Project Number: SP2018-025
Project Name: Office Building
Project Type: SITE PLAN
Applicant Name: PSA ENGINEERING, LLC
Owner Name: ROCKWAY, PARTNERS LLP
Project Description:

RE: SITE PLAN (SP2018-025), Office Building

Project Number SP2018-025	Owner ROCKWAY, PARTNERS LLP	Applied 7/17/2018 LM
Project Name Office Building	Applicant PSA ENGINEERING, LLC	Approved
Type SITE PLAN		Closed
Subtype		Expired
Status P&Z HEARING		Status 7/24/2018 DG

SCALE:	AS SHOWN
DESIGNED:	P55
DRAWN:	P5A
CHECKED:	P55
PROJECT NO.	21737.VPR
DATE:	JULY 16, 2018
SHEET:	C-01

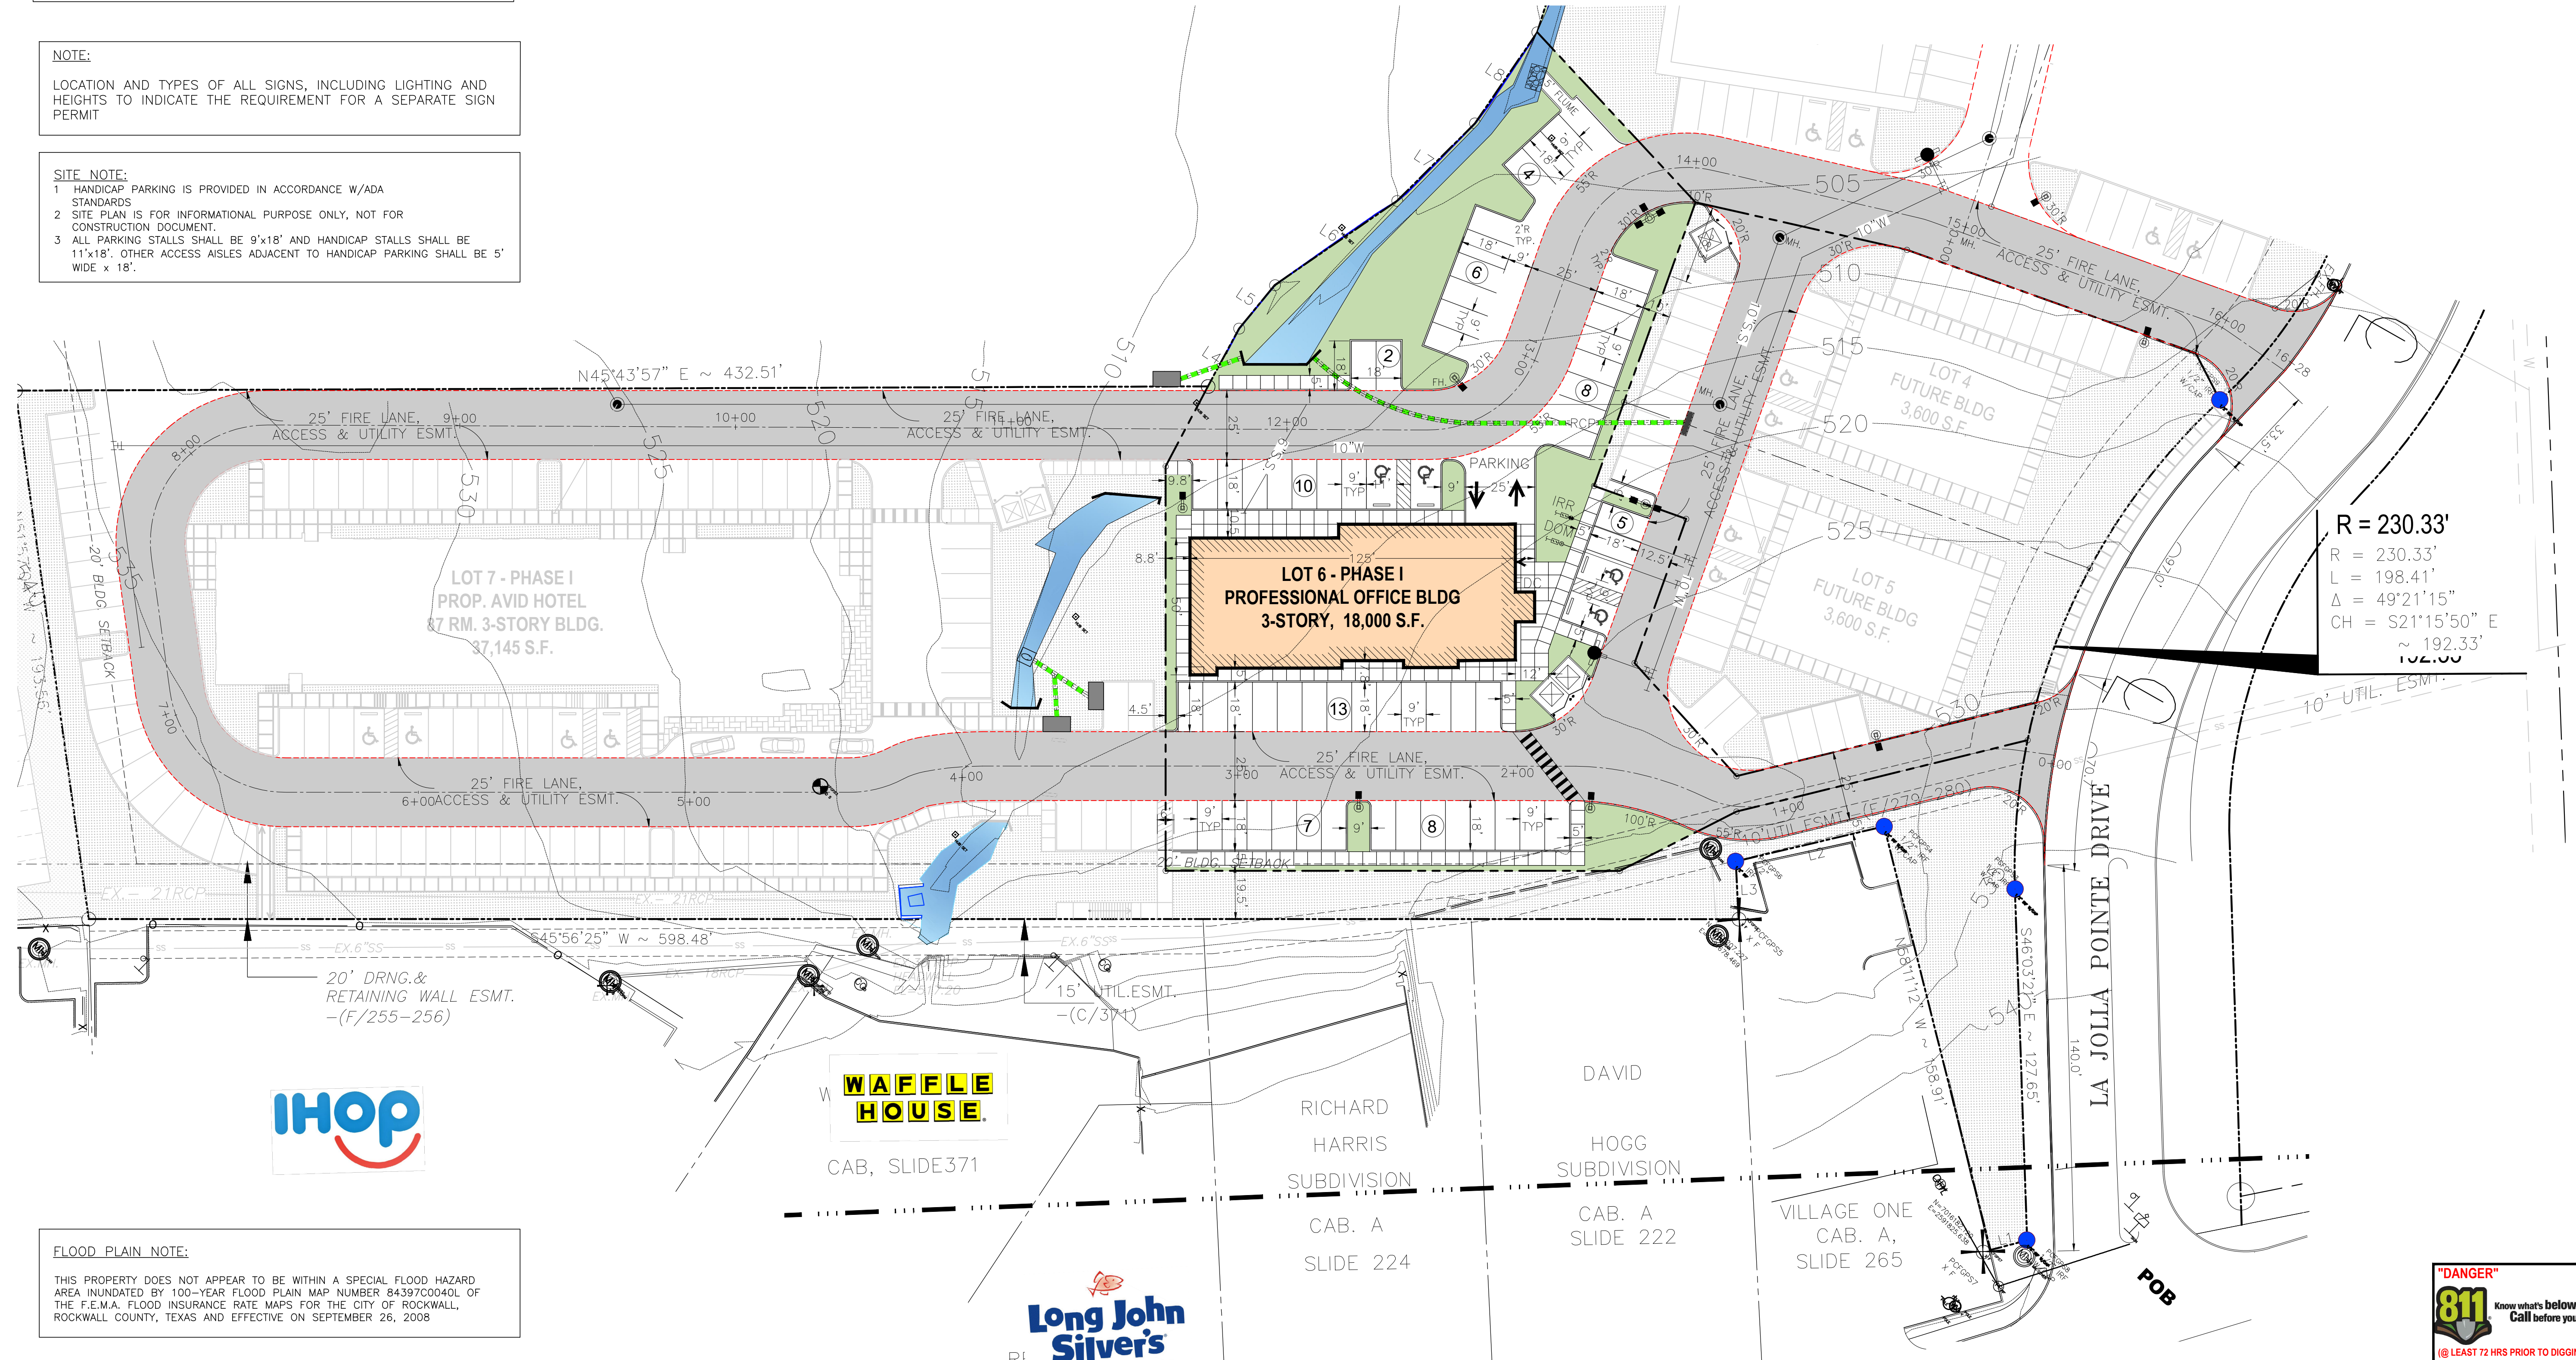
<p>** Please address the following Planning Comments for each plan submitted</p>						
<p>Site Plan:</p>						
<ol style="list-style-type: none"> 1. Lot as depicted does not meet the minimum standards for a legal lot; minimum 60-ft frontage along a public street and a minimum of 100-ft lot depth. Submit preliminary plat concurrently with site plan. 2. Relabel all firelane as '25-ft Firelane, Public Access & Utility Easement as appropriate (i.e. if no utility within easement, do not include Utility).

Type of Review / Notes	Contact	Sent	Due	Received	Elapsed Status	Remarks
3. Dumpster enclosure to include a self latching gate mechanism and gate to be opaque with enclosure walls to a minimum of 8-ft in height and the exterior materials matching the primary structure.						
4. Provide a minimum 10-ft landscape buffer along La Jolla Pointe Drive and label as such when lot is reconfigured						
5. Verify parking count; two (2) spaces short (i.e. 61 spaces) = east are marked 5, has 4 spaces & north area marked 10, has 9 parking spaces. Also provide a garage layout indicating the parking spaces to be used.						
6. Verify building length-- not equal to what is depicted on elevation drawings. Verify and correct.						
7. Verify scale of 1 inch = 40-ft.

SHEET: L-01

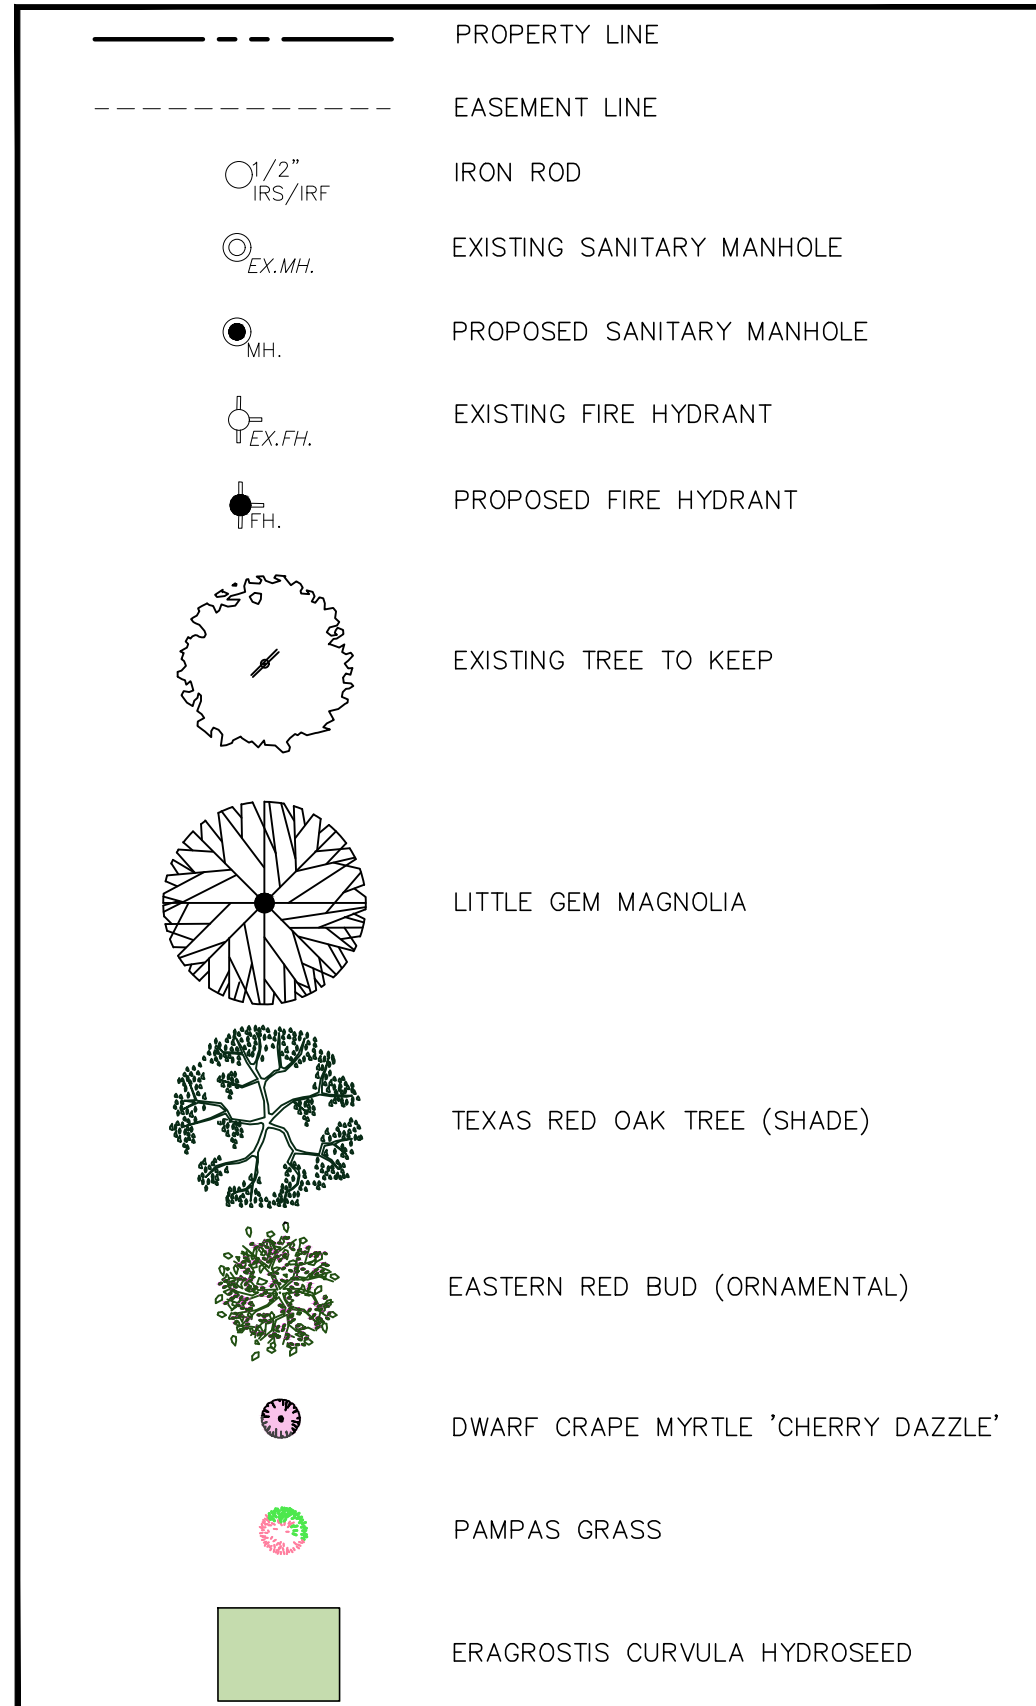
Landscape Plan:

1. Provide a row of trees behind the perimeter of the building per SOV standards
2. Parking space not to be more than 80-ft from the trunk of a large tree. Provide trees in islands.
3. Correct legend to indicate 7,054 SF of landscaping required (47,027 SF x 15%).

SCALE:	AS SHOWN
DESIGNED:	PSS
DRAWN:	PSA
CHECKED:	PSS
PROJECT NO.	21737.VPR
DATE:	JULY 16, 2018
SHEET:	L-02

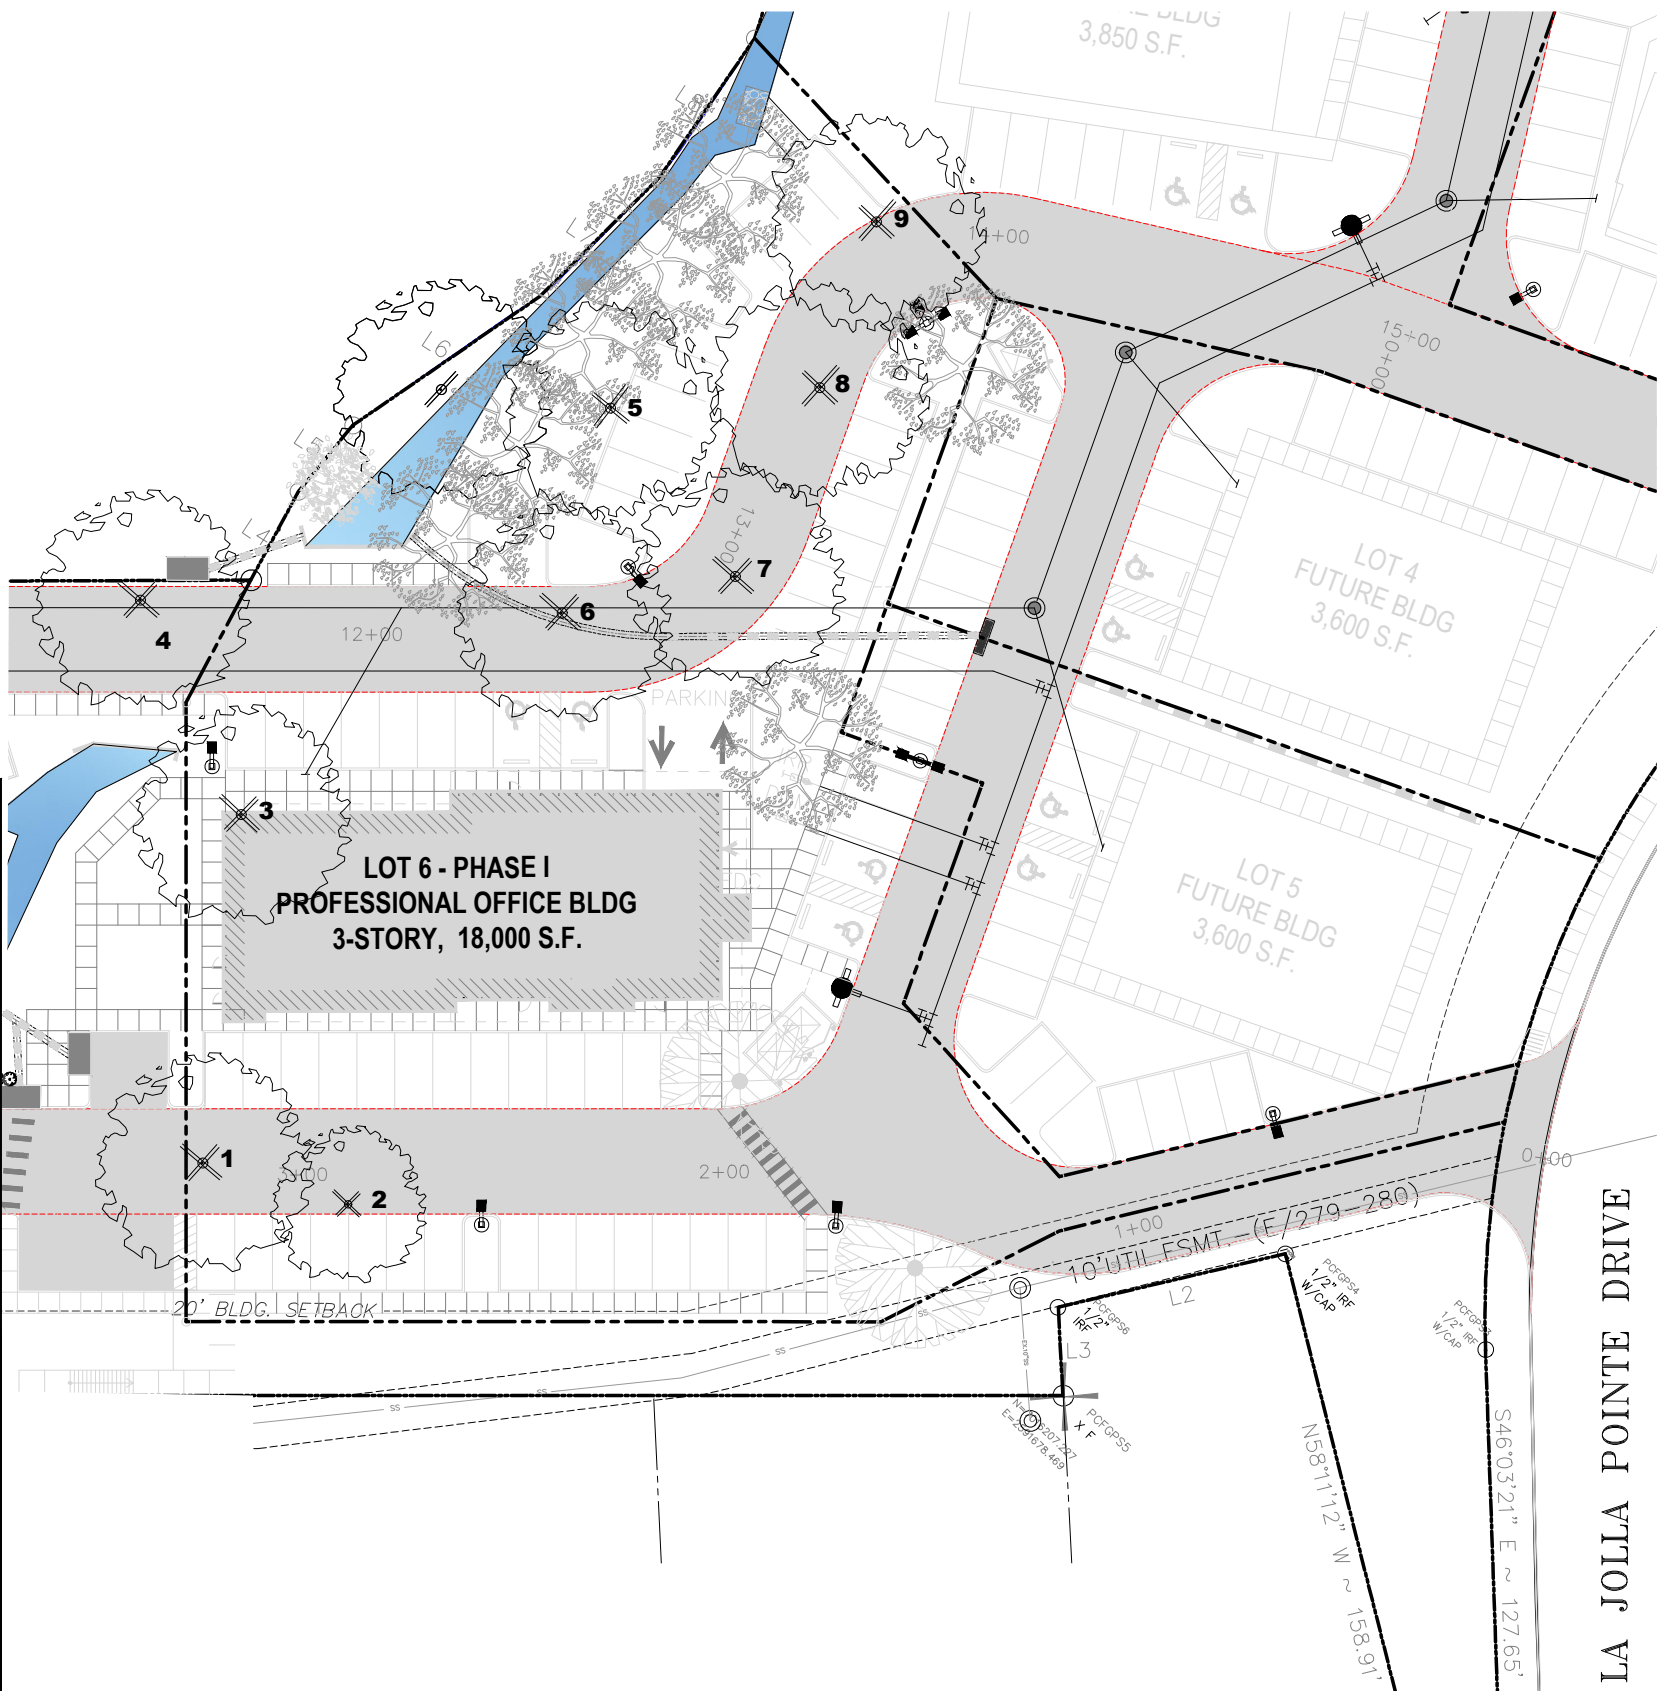
Treescape Plan:

1. Mitigation credit of 8 inches to be used towards mitigation balance [see SP2018-024 & SP2018-025] of 37 inches, which leaves a mitigation balance due of 29 caliper inches. Mitigation balance may be satisfied by either a) replacing 10 - 3 caliper inch trees on site, b) donate the trees to the parks department, c) provide a payment of up to 20% of the mitigation balance (20% x 29 inches = 5.8 inches @ \$100 per inch = \$580 to the tree fund, with the balance of 23.2 inches being planted/donated (i.e. 8 - 3 inch trees). If none of the above are preferred, the applicant may request an Alternative Tree Mitigation Settlement Agreement which requires approval by the City Council in order for the applicant to pay 100% of the mitigation balance to the tree fund (i.e. \$2,900). Identify which method will be used to satisfy the mitigation balance.

SCALE:	AS SHOWN
DESIGNED:	P55
DRAWN:	PSA
CHECKED:	P55
PROJECT NO.	21737.VPR
DATE:	JULY 13, 2018
SHEET:	C-05

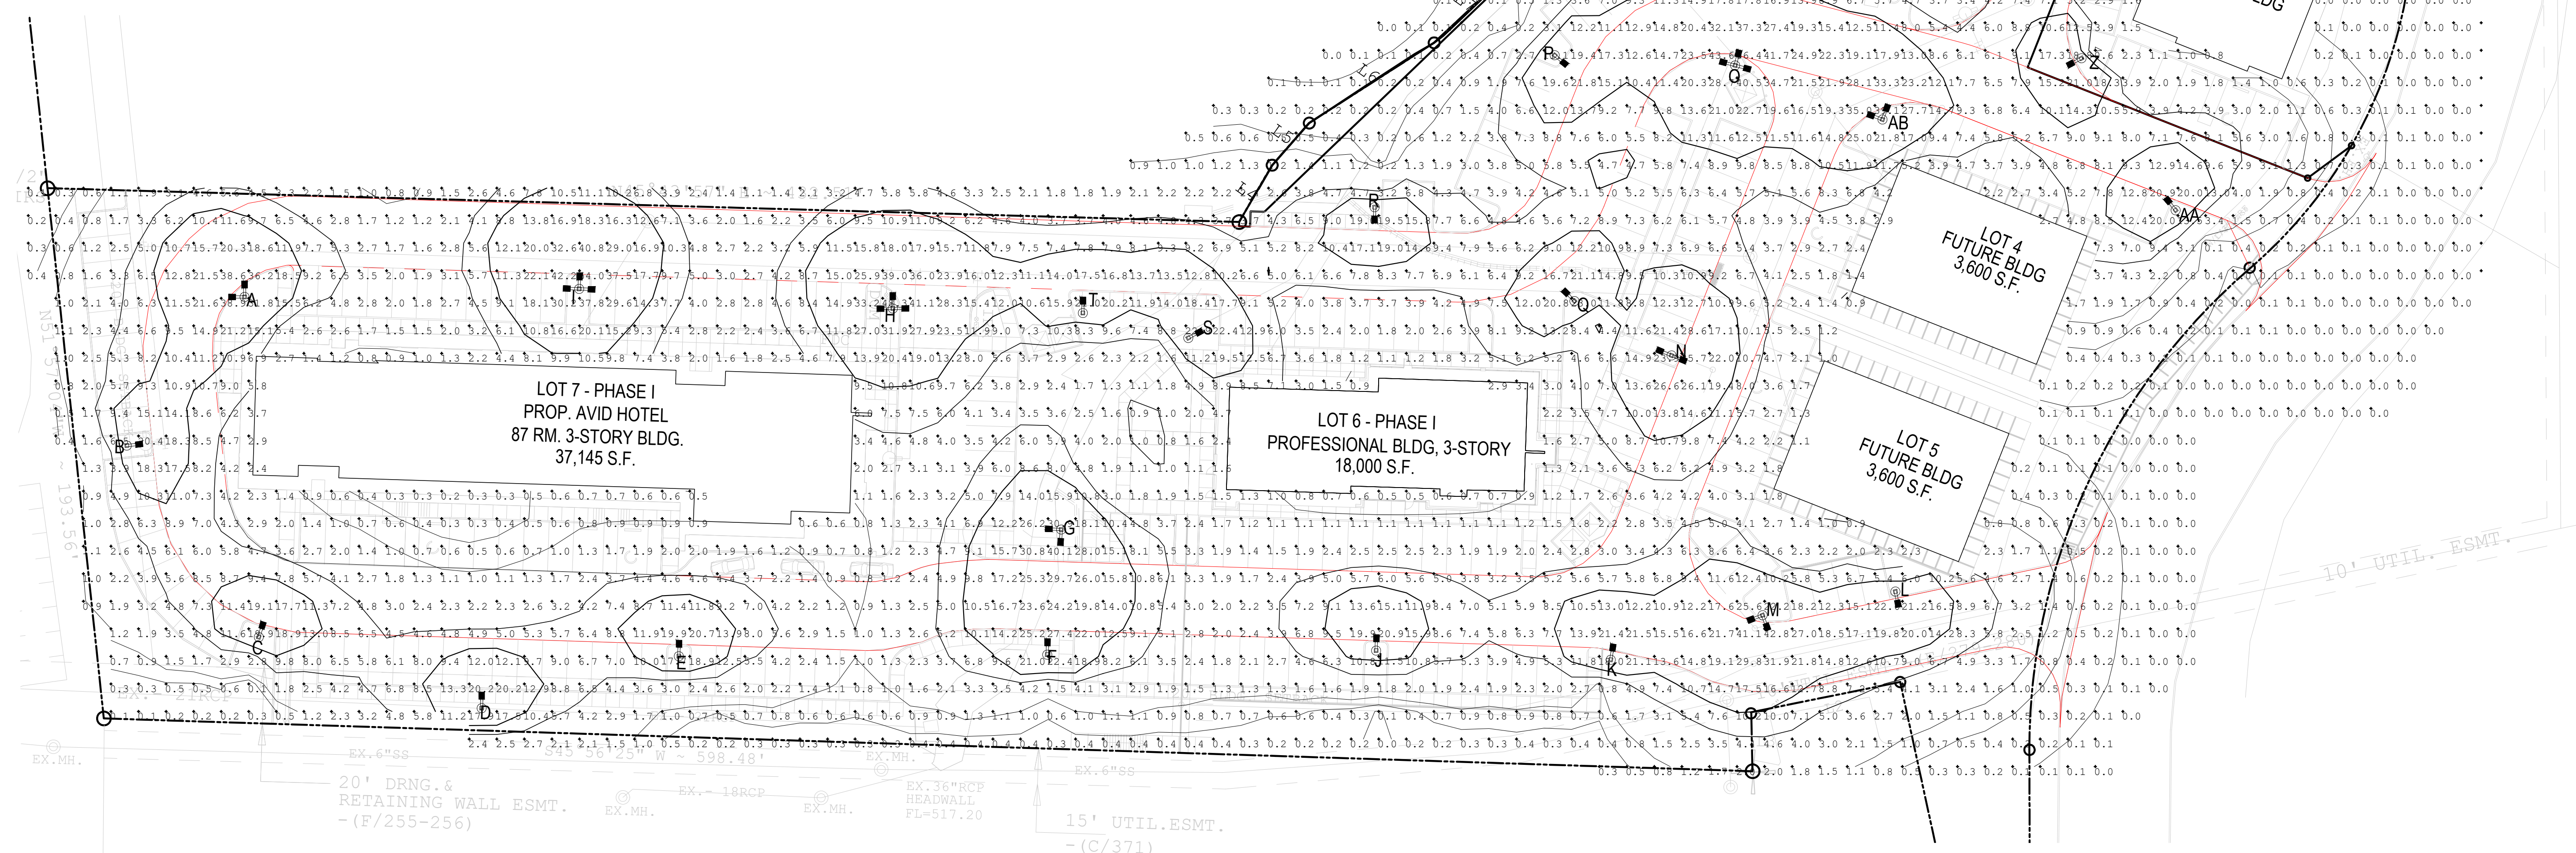
Photometric Plan:

1. Provide a separate photometric plan for each lot/development.
2. High readings indicated on the overall plan, both at the property line and the internal lots. Review City standards under Section 3, Article VII Environmental Performance, of the Unified Development Code with re-submitting each separate lot plan.
3. Exterior light pole detail indicates pole to exceed the maximum overall height of 20-ft. Adjustment or approval of a variance required as indicated above.
